Chapter 7 Items 7-1-12 through 7-23-12 August 21, 2014.

This is one of eight documents containing the preliminary actions of the A117.1 Committee regarding public comments received on the First Public Review Draft (October 2013) of proposed changes to the A117.1 Standard, 2009 edition. Each item was discussed at the meeting of Committee during the weeks of January 21st and July 14th of 2014, in Washington D.C. The Committee took action on each public comment and such action is specified herein. The actions listed here are subject reconfirmation by the Committee via the Committee's ballot process.

Chapter 7

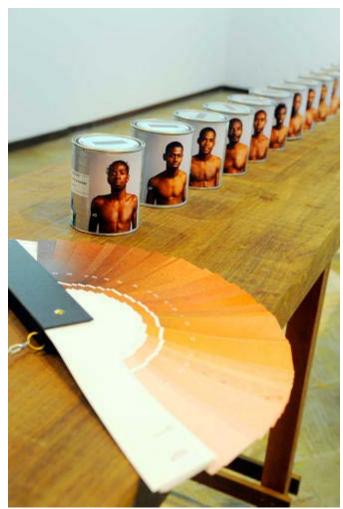
The current last sentence is grammatically incorrect and cannot be enforced consistently. The "full range of human skin tones" is quite broad and unless one is expert, is subject to interpretation (see picture in Supporting Information below). In addition, the extent of contrast is not specified. I've proposed a color in the bright green or blue range. This is based on the need for a background at the seating area and in view of a video camera that provides a contrast from a broad range of human skin tones to provide a background for signing. Bright green or blue are specifically used in the film industry (see Supporting Information below) as mattes because they are seldom within the human skin color spectrum and so enable the human to stand out. There may be other colors that work but this provision should include the degree of contrast and point to the contrast provisions proposed for A117.1. In addition, the current language appears to require the entire privacy screen to require contrasting color, not addressing the specific need of a background to the video area.

• From an article on photography and green screens, Creating Realistic Composites, Part 1: Shooting on a Green Screen by Rob Taylor (http://photography.tutsplus.com/tutorials/creating-realistic-composites-part-1-shooting-on-green-screen--photo-14288)

"Why am I choosing green? Well, chroma green is a color rarely found in nature, particularly human skin tones, so people stand out nicely in front of it."

Approve Public Comment 7-16-12 PC2.

Reason: The comment provides some improvement to the text. By approving amendments to the provision, the issue will be in the next public review draft and available for additional comments to improve the standard.
